Notice of switch parts in magnet assembly for AC brake

Subject	Notice of switch parts in magnet assembly for AC brake	Date of issue	March 1, 2019
		MITSUBISHI ELECTRIC FA INDUSTRIAL PRODUCTS CORPORATION 1-1-1 Imajuku-Higashi, Nishi-ku, Fukuoka 819-0192 TEL 092-805-3631

No. 855-0308 (2/2)

① Brake Coil (200V class)

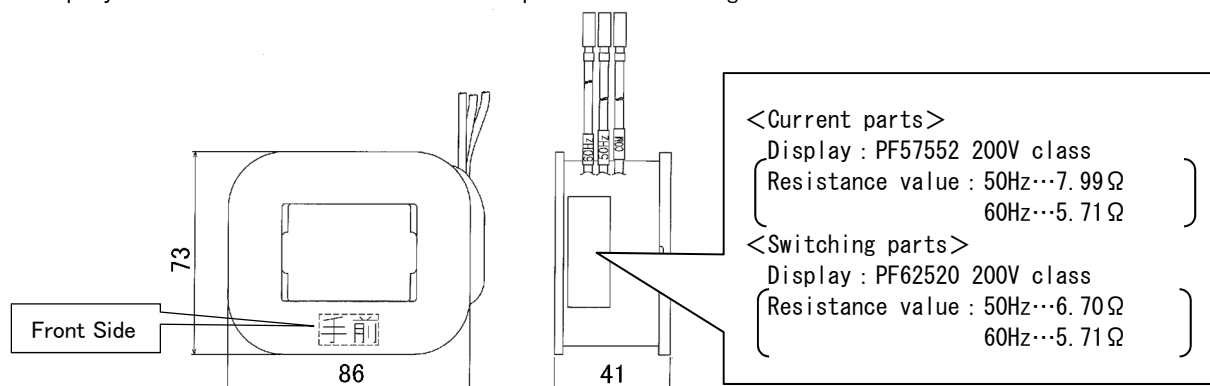
- Dimensions, appearance : There is no difference between current parts and switching parts.
(Roll frame : brown, coil surface : yellow)
- Compatibility : Compatible in assembly
- Display : Brake coil's production drawing number is indicated on lead wire side.

②Movable Core Support Metal

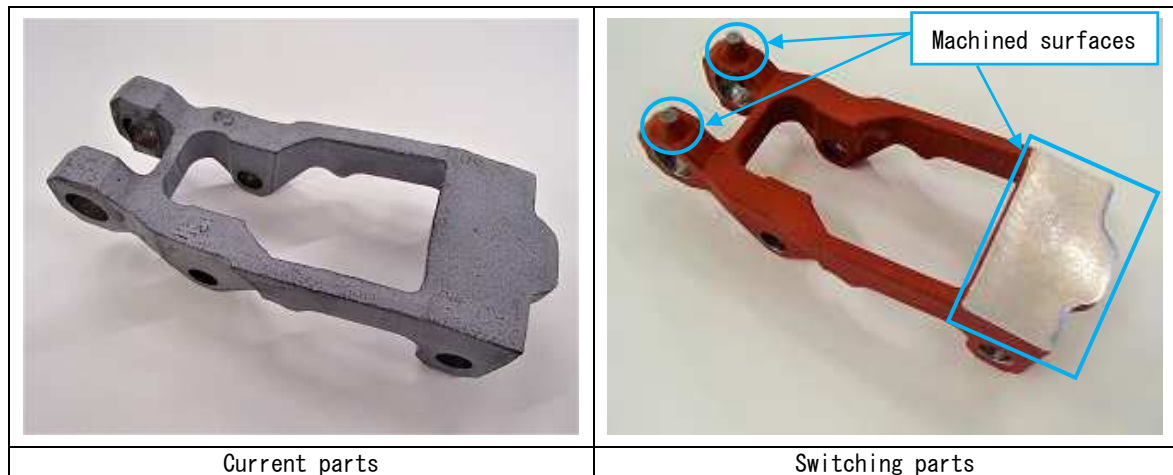
- Dimensions : There is no change in major dimensions.
- Color of paint : Gray → Red (There are machined surfaces)
- Compatibility : Compatible in assembly

- Appearance : As shown below.
